Product Change Notification

PCN-ICC-7446-2021

Description for Product Change Notification

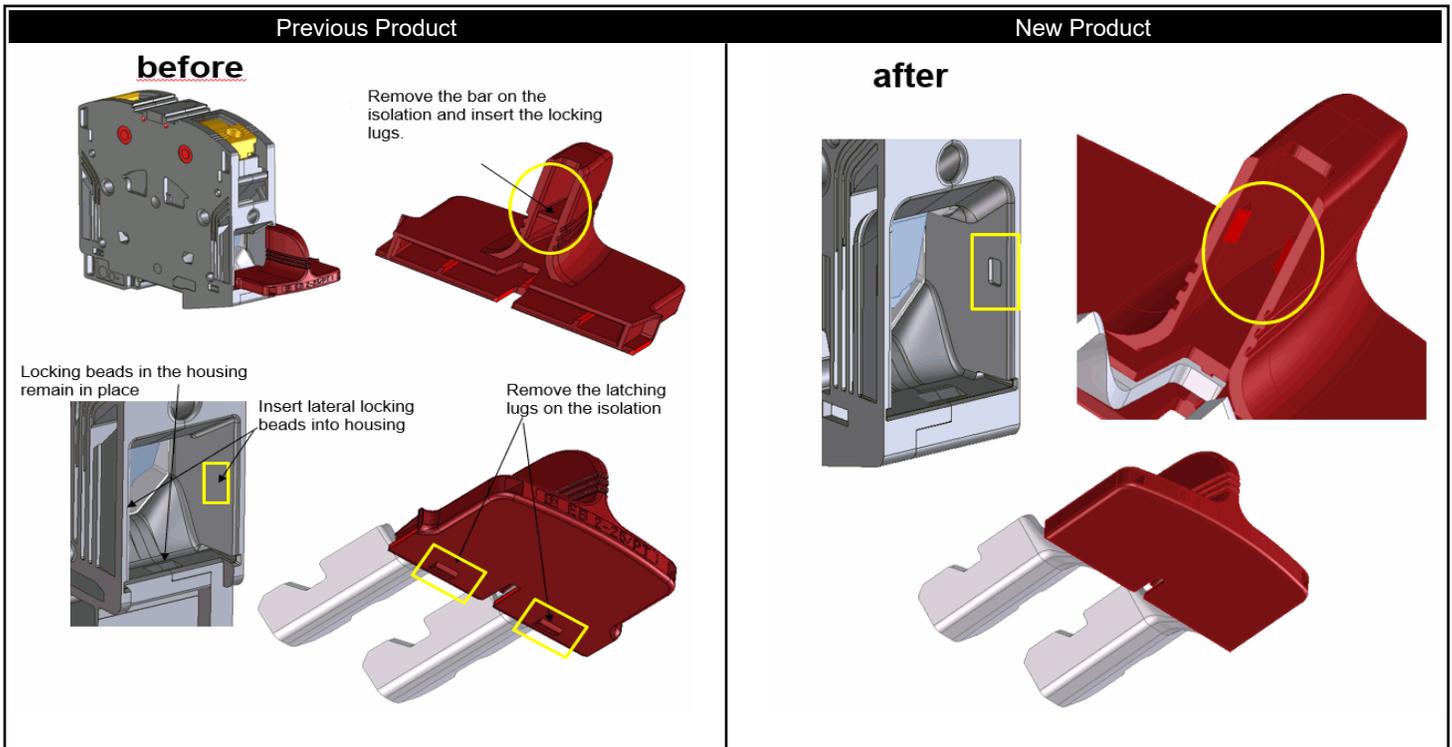
In order to ease the removal of EB insertion bridges, both the bridges and the PTPOWER 95 terminal blocks have been modified and improved. They now have the same latching principle as PTPOWER 50 and 185.

The snap-in latch on the EB insertion bridge is now set at a different position in the insulation. The PTPOWER 95 family has also been modified with new snap-in latches within the housing to accept the modified EB bridges and to make removal of these bridges from the terminal block easier.

V/C 01 insertion bridges may be used in all version codes of PTPOWER 95. However, V/C 02 bridges may only be used in PTPOWER 95 V/C 09 or higher.
